## City of Coos Bay Community Development Department

### STAFF REPORT

**FILE NUMBER:** 187-ZON14-071

**REQUEST:** Applicant has applied for the following land use applications: Site Plan and Architectural Review (SPAR), and Variance.

**SITE PLAN**

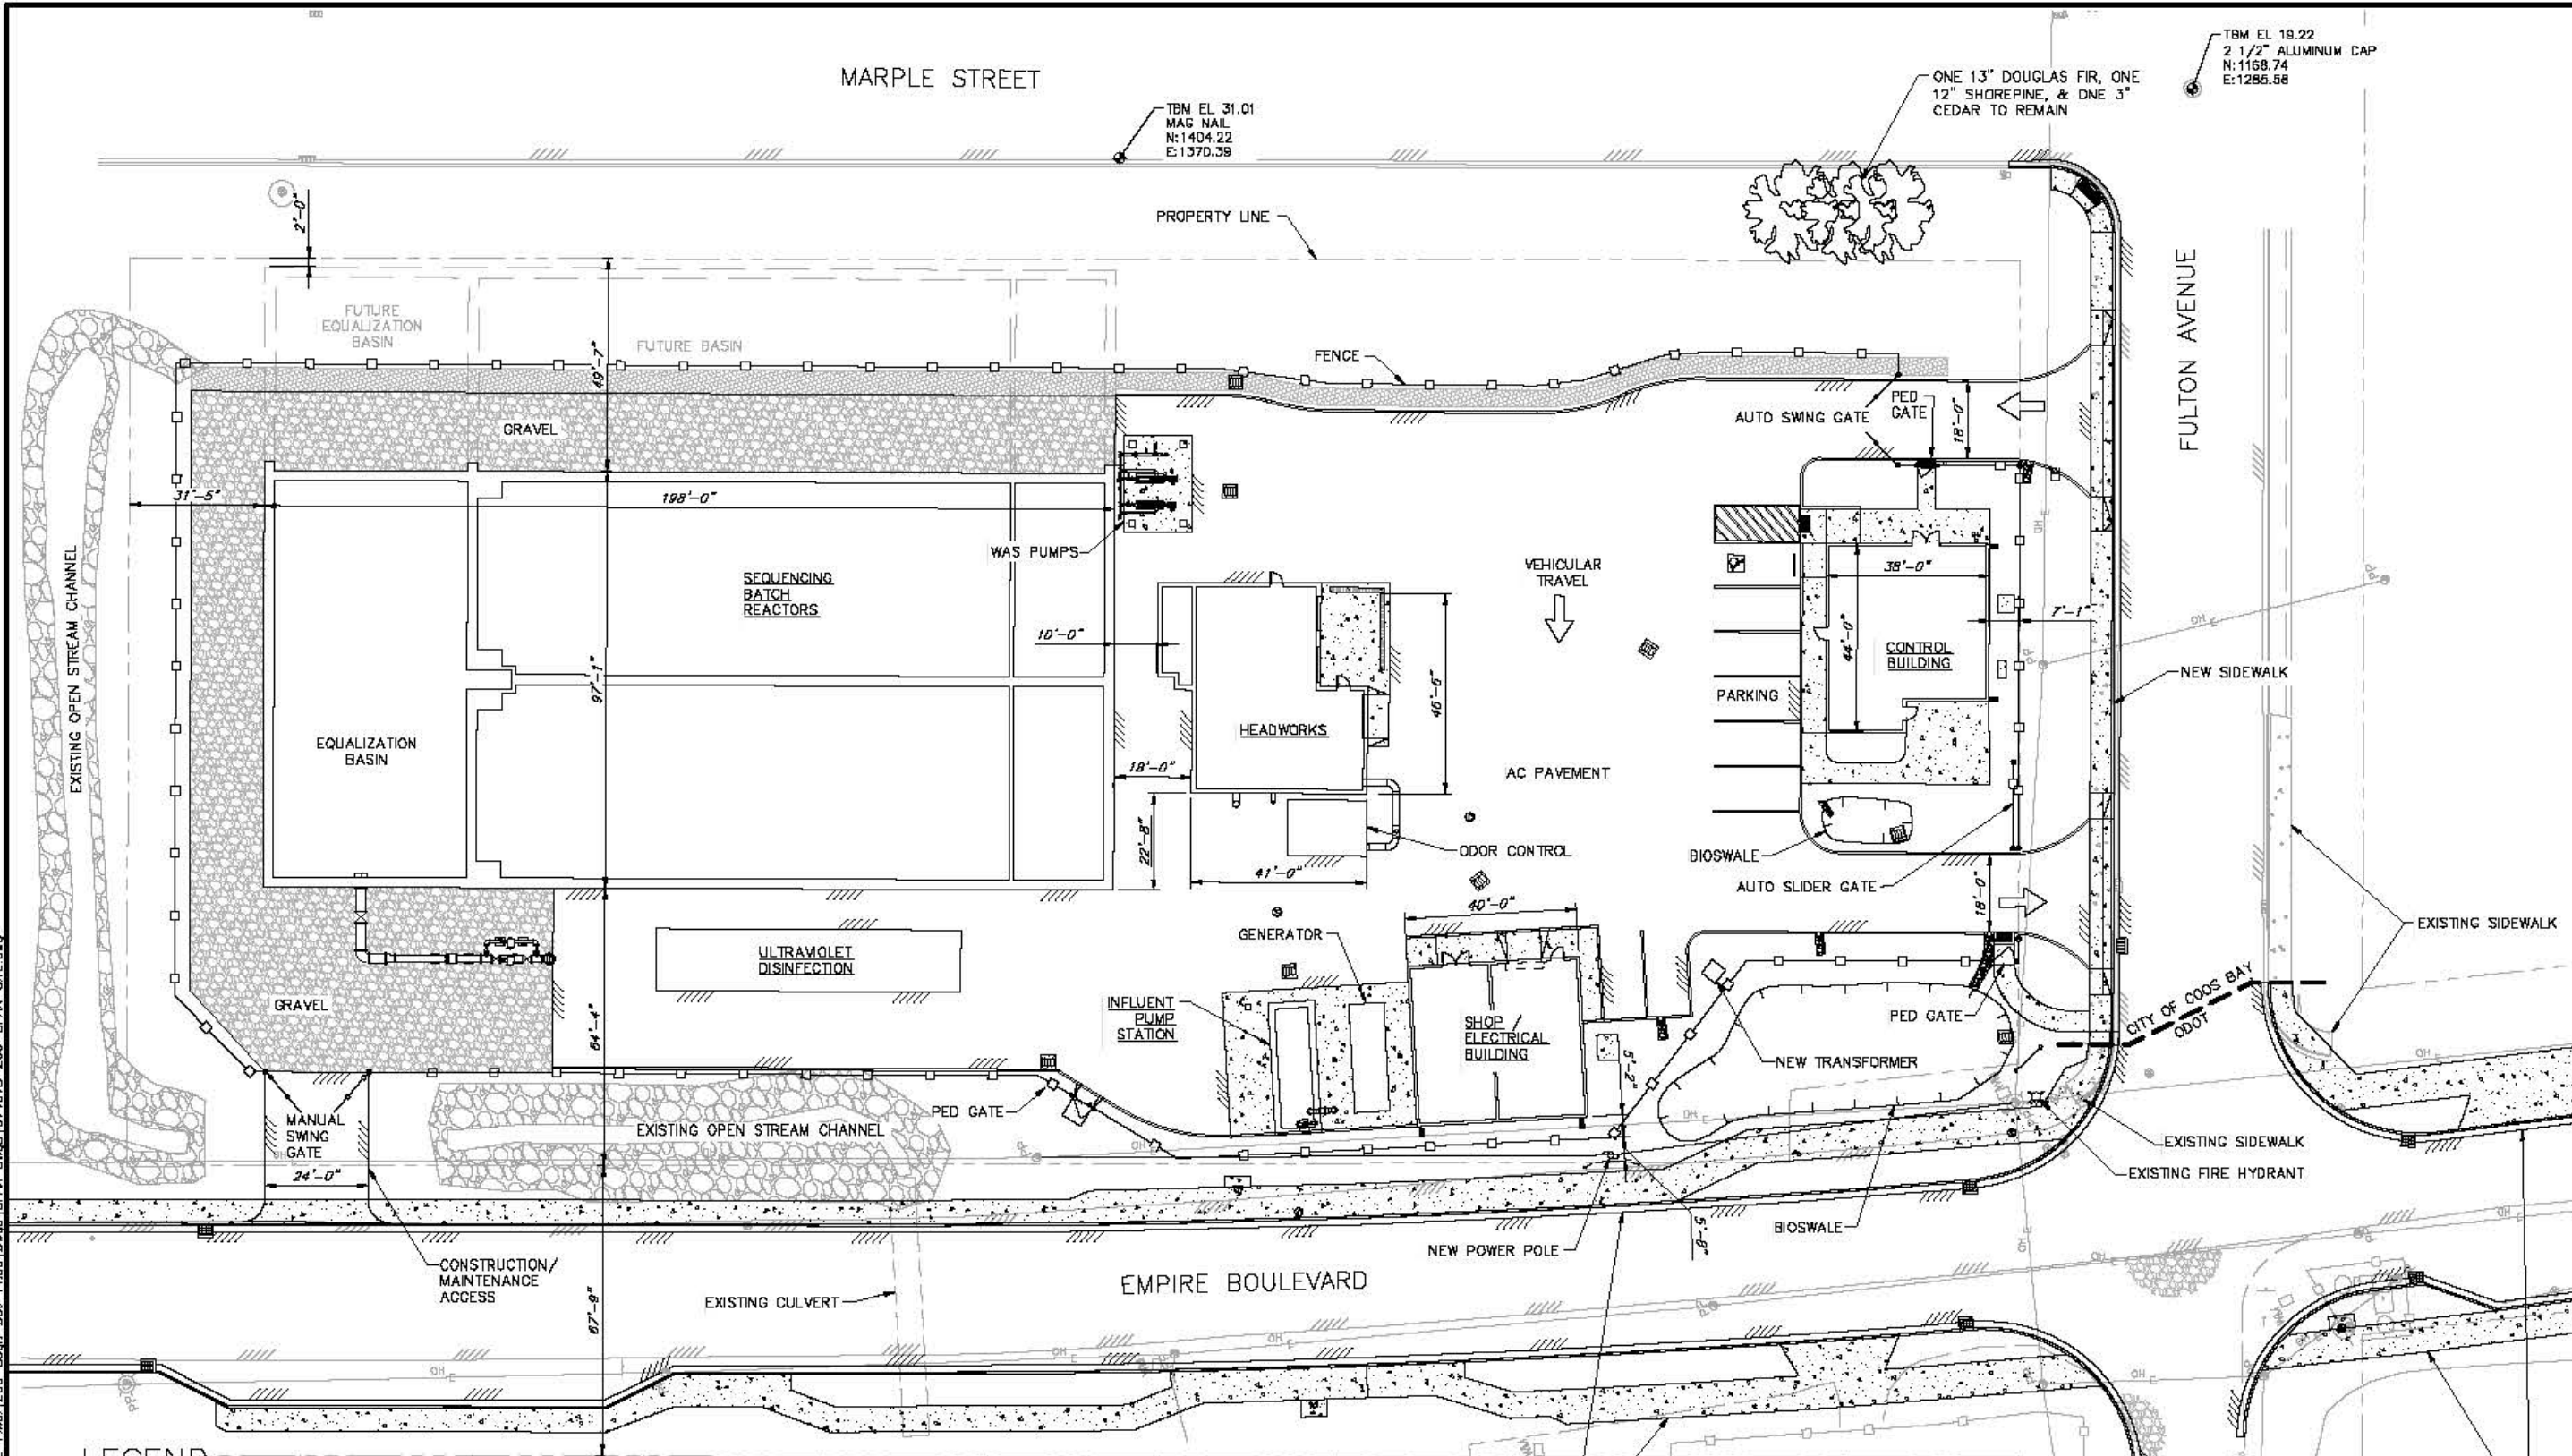
**Staff Response: The subject property has two existing access points on the south side from Fulton Ave. The access points are shown on the Site Plan (Part One, Exhibit A) as a part of the application. The proposed use is non-residential, so the minimum lot frontage of 30-feet in width does not apply.**

**Staff Response: Per the application access to the site will be from Fulton Ave. The two primary property access are existing are not proposed to be modified. A variance is being applied for, as a part of this application, to allow for a third access point from South Empire Blvd. As described in the variance application, this third access would only be used for infrequent maintenance activity.**

**According to the applicant the 18-foot wide entrance from Fulton Ave is adequate for fire equipment access however, nothing is provided in the record to substantiate this claim. As a condition of approval the applicant shall submit a letter into the record from the Coos Bay Fire Chief stating that this is sufficient for fire access and turnaround requirements or make the necessary plan changes to accommodate the access requirements.**

**Staff Response: The proposed 6-foot tall fence is within all property lines and not within the vision clearance area. The fence layout is shown in the Application, Part One, Exhibit A – Site Plan. The fence details are provided in Part One, Exhibit D – Architectural Plan Set.**

**EXHIBIT C**  
**LANDSCAPE PLAN**

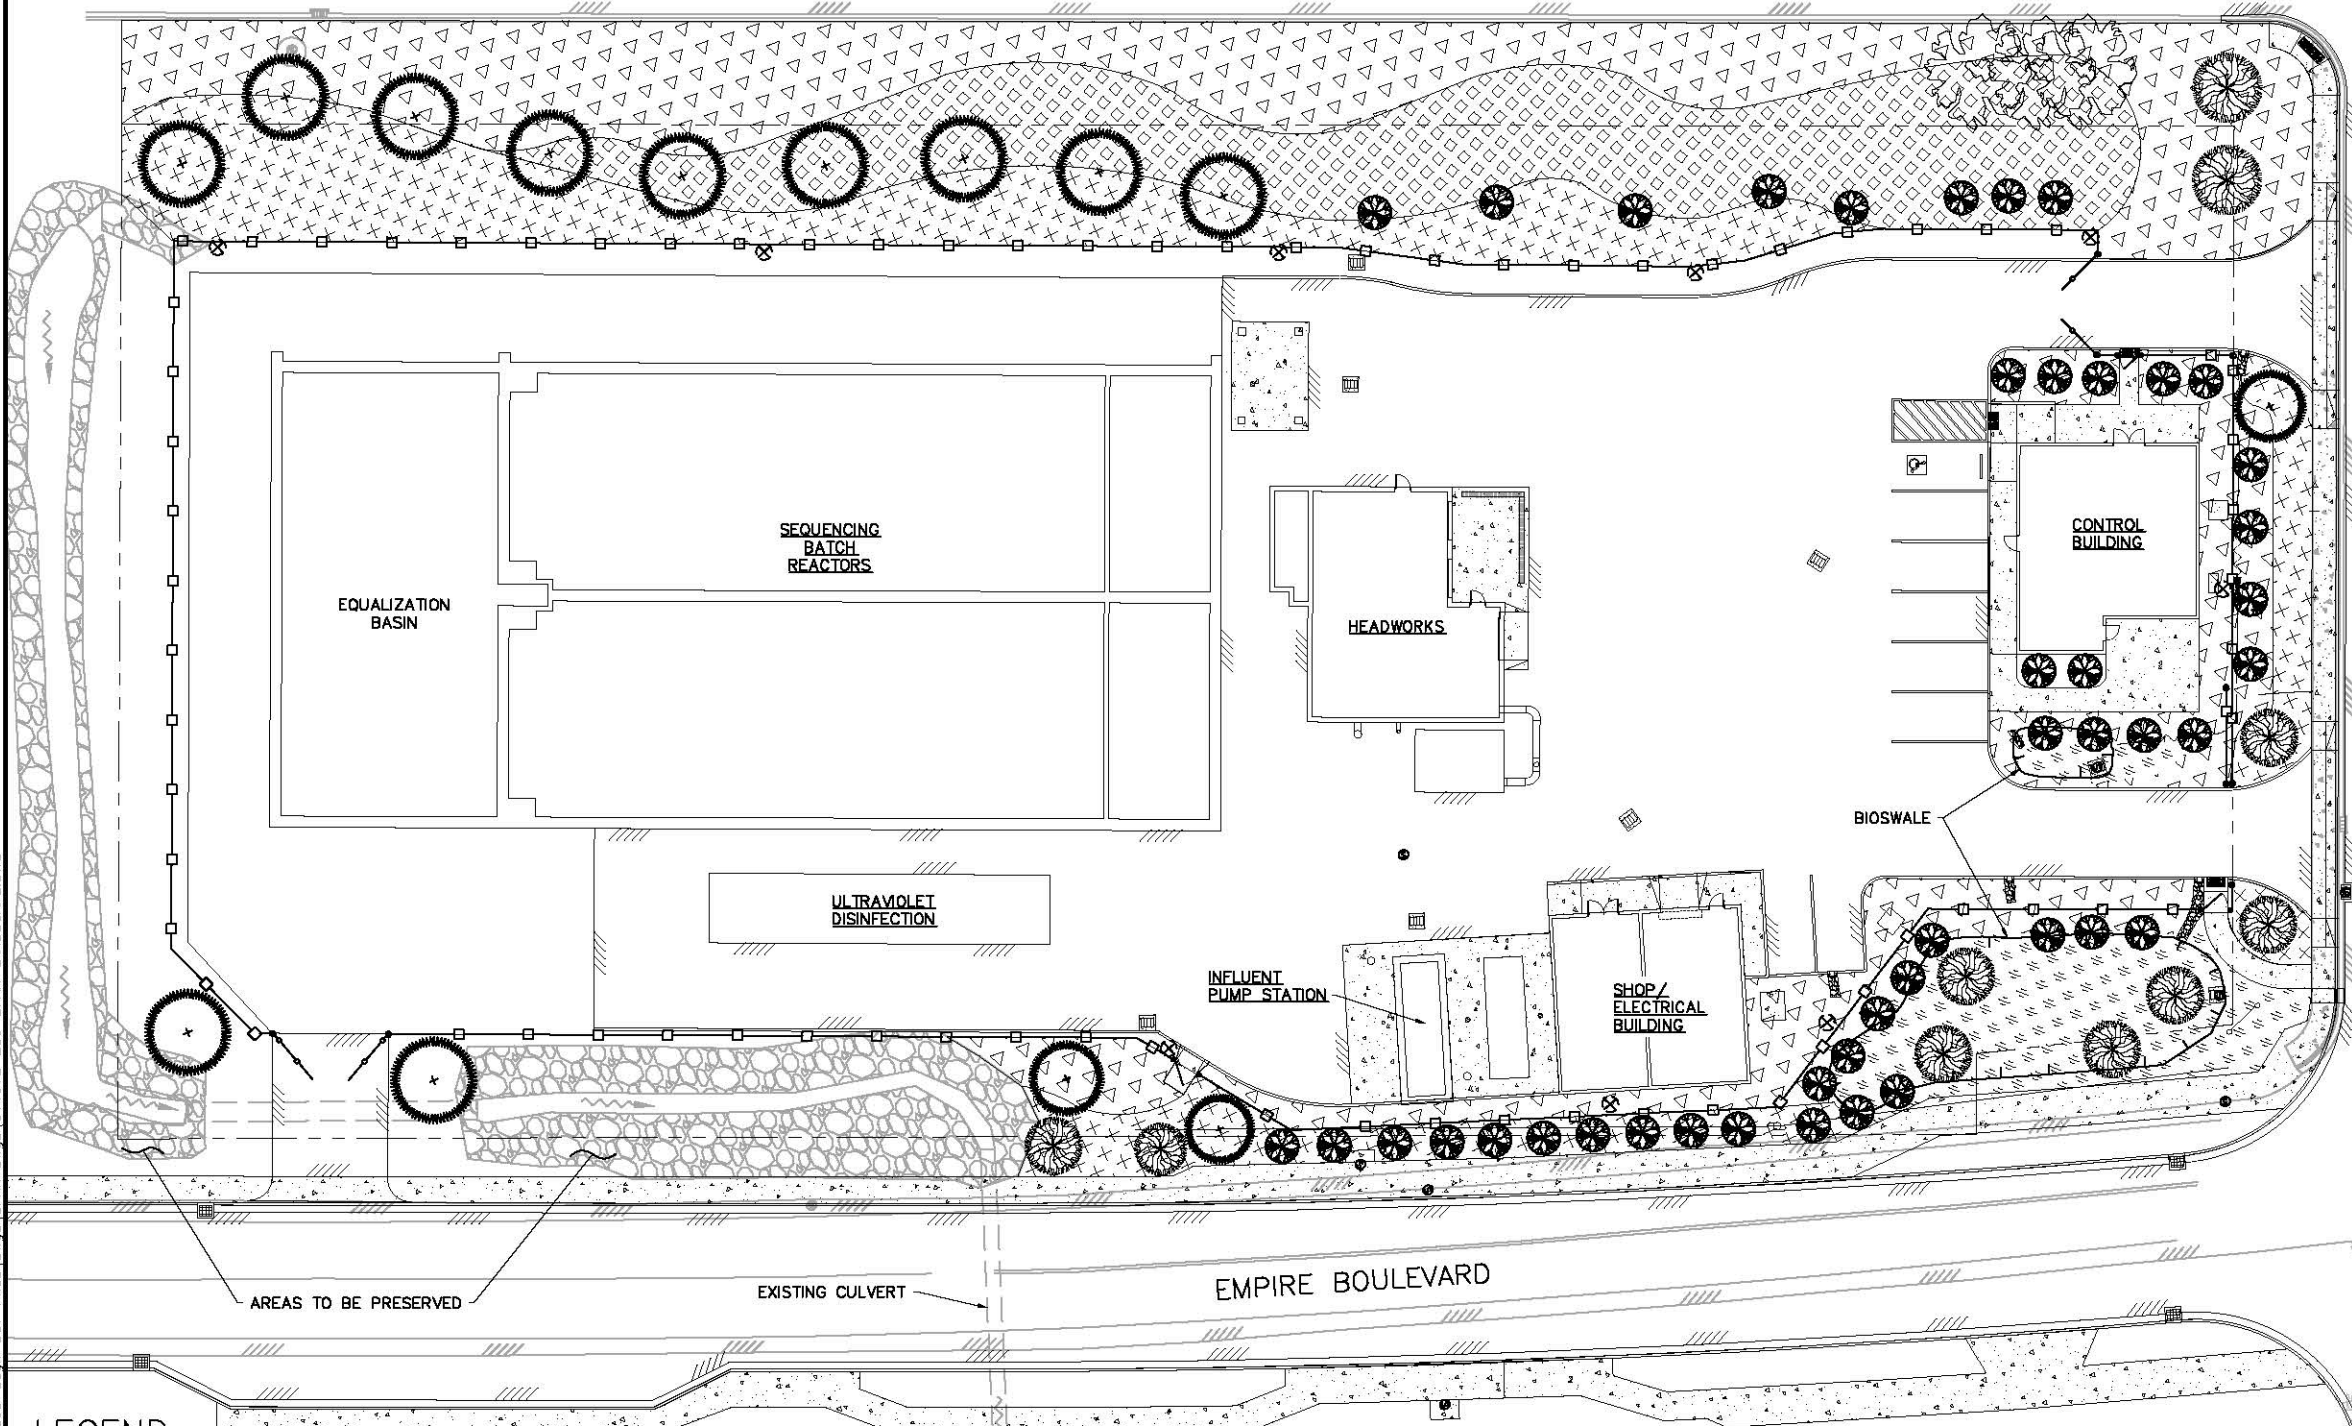
**Staff Response: As less than ten (10) spaces are being proposed by the applicant the landscaping requirements are waived. However, the applicant is proposing to landscape several areas as a part of the application (See enclosed landscaping plan).**
